*Bridge Preliminary Design Report*

**SR-823 over Norfolk Southern Tracks and US-23  
SCI-823-1601**

**SCI-823-10.13  
PID No. 79977**

Prepared for  
**Ohio Department of Transportation**

**PLAN**

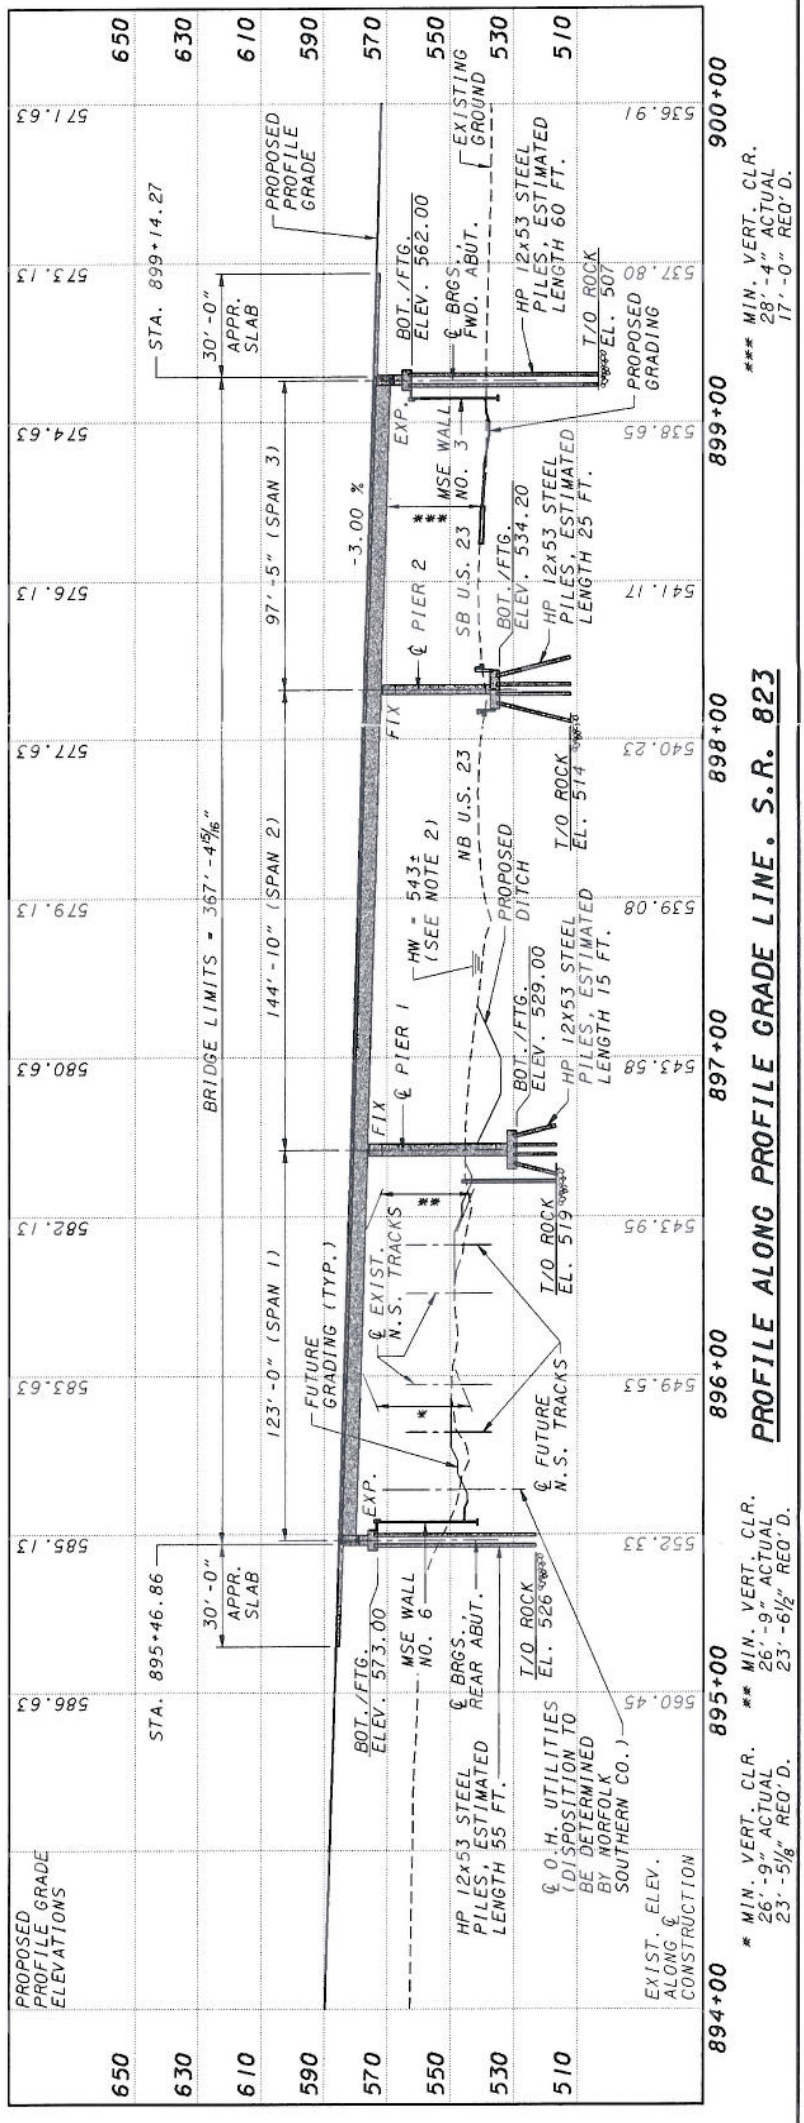
2. 100-year High Water Elevation shown on the Site Plan should be changed to 100-year Scioto River Backwater High Water Elevation.
3. There is no need to show Normal Water Elevation for a ditch.

7. Provide Structure File Number (SFN) in the title blocks of bridge plans.
8. PID number shown on Site Plan should be revised to 79977.

<p>Site Plan (1/3)</p>	<p>4. Investigate if the culvert under the SR 823 Bridge can be brought into alignment with culverts under the RR. This is similar to the previous submission dated 07-05.</p>	<p>The drainage plan for the project was revised after the Type Study for this bridge was submitted. The proposed culvert under US 23 is now located at STA. 609+50, south of the proposed SCI-823-1601 structure. Due to insufficient hydraulic capacity of the existing railroad box culvert, an additional culvert is being proposed under the railroad at RR STA. 587+60. Flow from the two railroad culverts will lead to the proposed culvert under US 23. The location of the new proposed culvert under US 23 also addresses Review Comment #4 from the previous submission dated 07-05, by avoiding conflicts with proposed pier footings.</p>
----------------------------	--	---

<p>Site Plan (1/3)</p>	<p>5. The Top of the Pier 1 footing should be 3'-0" below the proposed ground elevation.</p>	<p>The drainage plan for the project was revised after the Type Study for this bridge was submitted. The proposed culvert under US 23 at Sta. 611+00 has been relocated to Sta. 609+50±. This results in a ditch running parallel to Pier 1. The bottom of the ditch is at Elev. ±535.70'. BDM Section 303.3.2.2 states that the top of a footing should be a minimum of 1'-0" below the bottom of an adjacent ditch. If a 3'-0" thick footing and 30" of rip rap are used, then the bottom of footing elevation would have to be approximately 529.00' (535.70' - 2.50' - 1.00' - 3.00'), which is the bottom of footing elevation shown on the Site Plan. For this reason, CH2M HILL recommends that the bottom of footing elevation change to Elev. 529.00'. As the ditch design progresses, we will reevaluate the footing elevation to ensure that the top of footing is 1'-0" minimum below the bottom of the ditch.</p>

<p>Site Plan (1/3)</p>	<p>6. When the deck drainage is to flow off the bridge, provisions must be made to collect and carry away this run-off. Please refer to the Bridge Design Manual (BDM) section 209.3.</p>	<p>Will comply.</p>
<p>Site Plan (1/3)</p>	<p>7. Provide the Structure File Number (SFN) in the title blocks of the bridge plans.</p>	<p>Will comply. CH2M HILL has been notified that the Structure File Number for this bridge is 7306792.</p>
<p>Site Plan (1/3)</p>	<p>8. The PID number shown on the Site Plan should be revised to 79977.</p>	<p>Will comply.</p>

Reference Page/Sheet No.	Review Comment	Designer Response
	<b>ODOT Comments</b>	
General	1. The backwater from Scioto River will not cause any scour at the piers or abutment, because the water will not have any significant velocity. A hydraulic analysis and scour analysis are not justified. The MSE walls do not require any special materials or construction procedures due to possible scour.	Will comply.
Site Plan (1/3)	2. The 100-year High Water Elevation shown on the Site Plan should be changed to 100-year Scioto River Backwater High Water Elevation.	Will comply.
Site Plan (1/3)	3. There is no need to show Normal Water Elevation for a ditch.	Will comply.

Stability Analysis  
 MSE Wall No 3 Sta. 899+07  
 Based on profile from B-54  
 & TR-49  
 SR 823 over NS RR and US  
 23, Forward Abutment  
 H=39.4'  
 (Height includes embedment)  
 3.0' minimum embedment  
 L=0.85H =33.5'

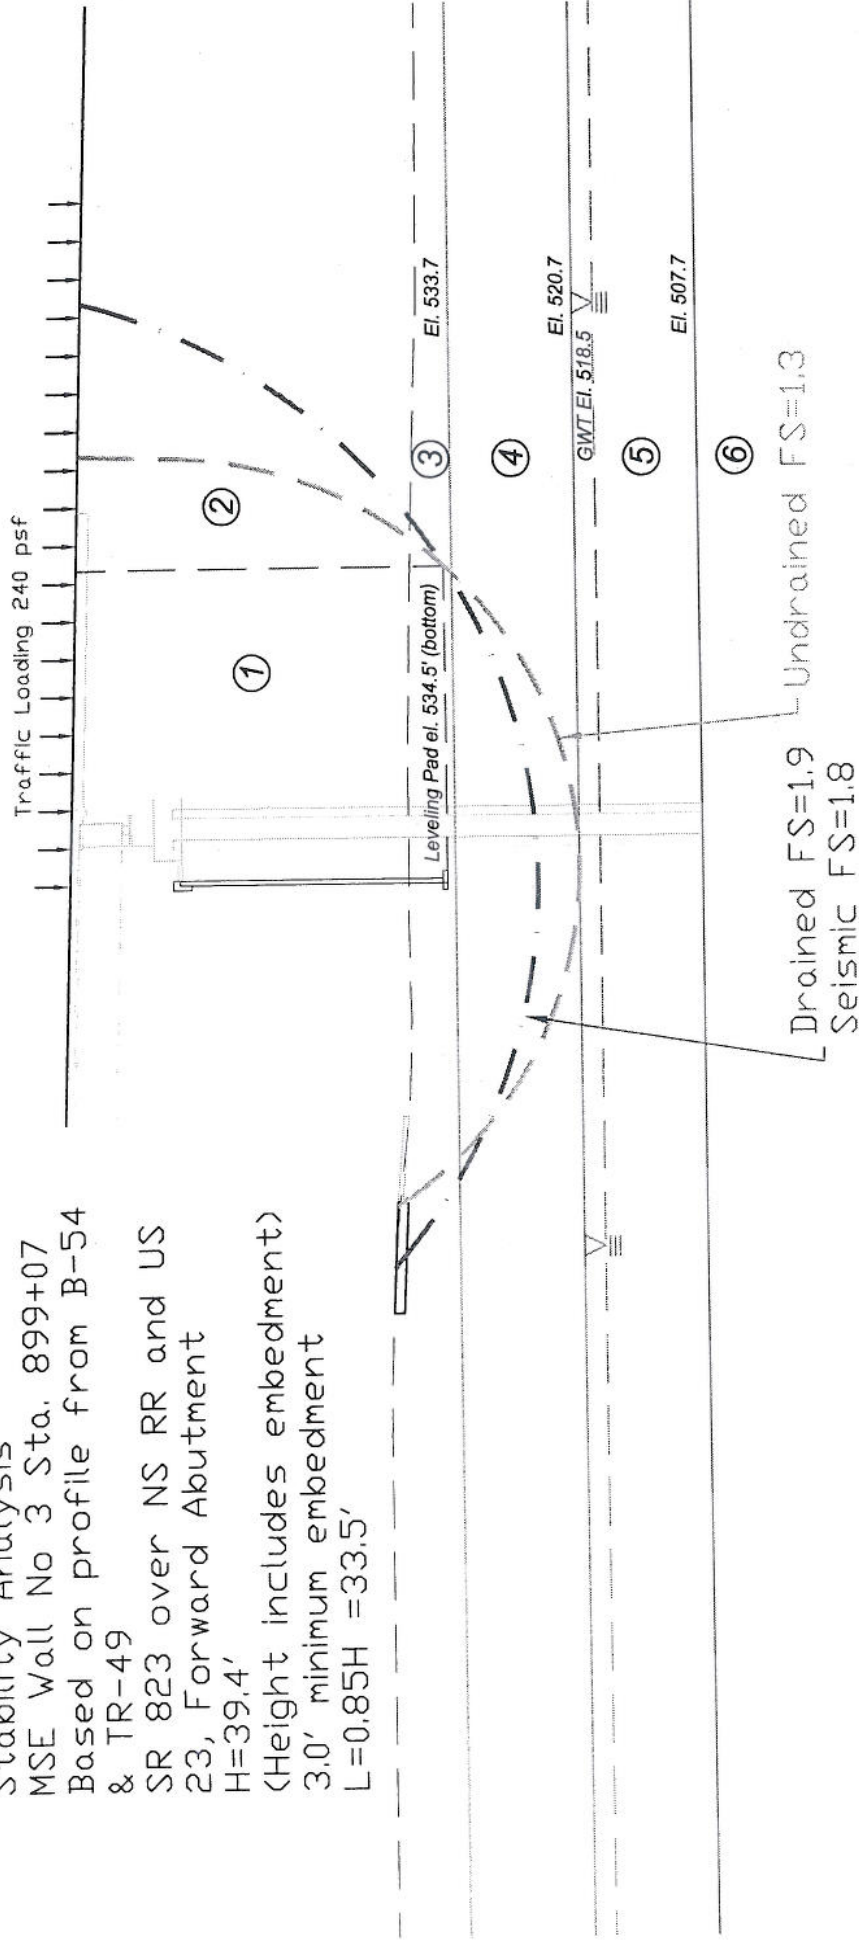
Page 7 of the report, and the calculations for the wall, show the bottom of the leveling pad to be at elevation 541.2 (3-ft of embedment). Bearing Capacity, Sliding, and Global Stability Analysis show the bottom of the leveling pad being in loose, free draining sand (A-2-6). However:

1. I believe that bearing capacity, sliding and global stability analysis should be evaluated using the two soils encountered in the borings and denoted on page 7 of the report.
2. As per FHWA Manual "Mechanically Stabilized Earth Walls and Slopes", global stability analysis should include circular, deep seated, wedge, and block failures. The analysis provided was only for a deep seated circular failure in the A-2-6 material (granular soil). A block-wedge failure would be the appropriate failure mechanism for this soil.
3. Please clarify if buoyant unit weights of soil were used in the global, bearing, and sliding calculations.
4. Please clarify that the high water table was considered/included in the bearing capacity calculations.
5. Page 4 of 23 of the calculations notes the presence of the A-6a and A-4a material, but states to neglect them for settlement computations. Please clarify.

6. The global stability analysis used a  $c = 2000$  psf for material #3 (A-6b/A-4a). Please clarify and amplify which specific borings and lab tests were used to establish this value.
7. Construction of this wall will require an approximate 15-ft cut into material three. The report doesn't address an acceptable short/long term slope angle to lay back this slope for reinforcement installation.
8. FHWA Manual "Mechanically Stabilized Earth Walls and Slopes" recommends on page 38 that for end slopes at bridges, wall embedment should be  $H/10$  or 4-ft in our case.

1. Global Stability, Bearing Capacity, and Sliding calculation used Layer 4 values of  $c = 900$  psf and an effective  $\phi$  of 28-degrees. Triaxial tests on Sample ST3 from boring B-54 (at Wall 3) showed  $c = 336$  psf. Please clarify the use of  $c = 900$  psf. In addition, using the  $c = 900$  resulted in a factor of safety of 1.3, which is the minimum allowed. Therefore, please clarify the sensitivity of the factor of safety to 10%-20% variations in  $c$  for layer 4.

3. The undrained sliding resistance factor of safety was show as 0.89 on page 10 of 23 of the calculations. In hand-written lettering, it says drained sliding  $FS = 1.68$ . Please clarify and expand on this calculation.
